Service Note

<u>16-007</u> 28 APRIL, 2016

T265 CONFIGURATION CHANGE

FIGURE 1

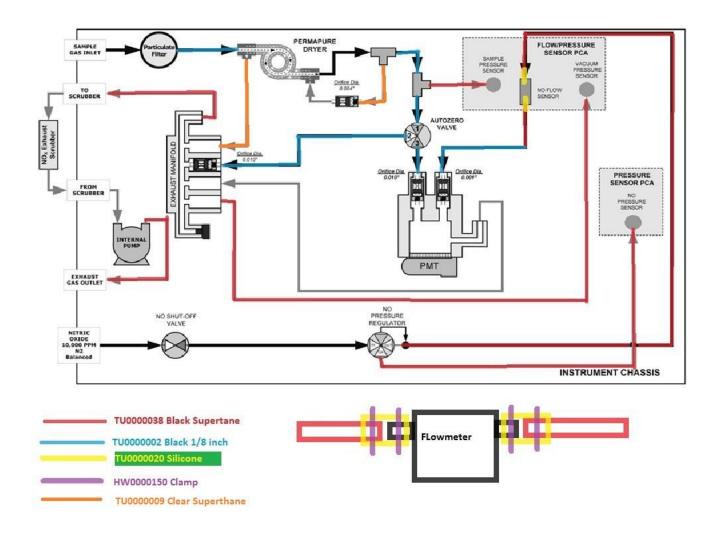
The T265 has had a configuration change. "Superthane" tubing is used everywhere inside of the analyzer instead of Tygon. The Tygon makes a yellow precipitates that may look like a material that could affect the instrument. Though we have not seen evidence of any compromised performance, it is recommended that the Tygon is changed out for Superthane.

- 1. Please contact Technical support at <u>SDA_Techsupport@teledyne.com</u> for required parts.
- 2. All Tubing and associated fittings need to be changed out. Refer to Figure 1 for reference.
